PRODUCT CHANGE NOTIFICATION

Select SRN Series Semi-shielded Power Inductors and SRP Series Shielded Power Inductors

Carrier Tape and Reel Temporary Change to Alternate Supplier

2.2 Comparison of dimensions:

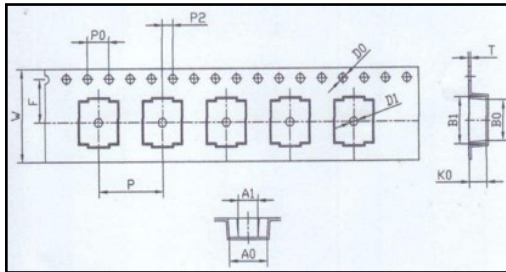
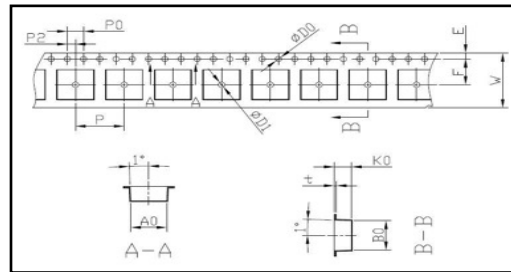
Original

Temporary

| Series | Type | W (mm) | P (mm) | D0 (mm) | P0 (mm) | A0 (mm) | B0 (mm) | K0 (mm) | t (mm) |
| SRP4020TA | Original | 12.0±0.3 | 8.0±0.1 | 1.5+0.1/-0 | 4.0±0.1 | 4.25±0.1 | 5.10±0.1 | 2.4±0.1 | 0.35±0.05 |
| | Temporary | 12.0±0.3 | 8.0±0.1 | 1.55±0.05 | 4.0±0.1 | 4.45+0.1/-0.05 | 4.85+0.1/-0.05 | 2.3±0.1 | 0.35±0.05 |
| SRP4012TA | Original | 12.0±0.3 | 8.0±0.1 | 1.5+0.1/-0 | 4.0±0.1 | 4.25±0.1 | 4.9±0.1 | 1.3±0.1 | 0.35±0.05 |
| | Temporary | 12.0±0.3 | 8.0±0.1 | 1.55±0.05 | 4.0±0.1 | 4.45+0.1/-0.05 | 4.85+0.1/-0.05 | 1.4±0.1 | 0.35±0.05 |
| SRN5020TA | Original | 12.0±0.3 | 8.0±0.1 | 1.50±0.1 | 4.0±0.1 | 5.40±0.1 | 5.40±0.1 | 2.20±0.1 | 0.35±0.05 |
| | Temporary | 12.0±0.1 | 8.0±0.1 | 1.55±0.05 | 4.0±0.1 | 5.30±0.1 | 5.30±0.1 | 2.30±0.1 | 0.35±0.05 |
| SRN5040TA | Original | 12.0±0.3 | 8.0±0.1 | 1.50±0.1 | 4.0±0.1 | 5.40±0.1 | 5.40±0.1 | 4.30±0.1 | 0.40±0.05 |
| | Temporary | 12.0±0.1 | 8.0±0.1 | 1.55±0.05 | 4.0±0.1 | 5.30±0.1 | 5.30±0.1 | 4.30±0.1 | 0.40±0.05 |
| SRN6045TA | Original | 16.0±0.3 | 12.0±0.1 | 1.50±0.1 | 4.0±0.1 | 6.40±0.1 | 6.40±0.1 | 4.70±0.1 | 0.40±0.05 |
| | Temporary | 16+0.2/-0.3 | 12.0±0.1 | 1.55±0.05 | 4.0±0.1 | 6.40±0.1 | 6.40±0.1 | 4.7+0.1/-0.05 | 0.40±0.05 |
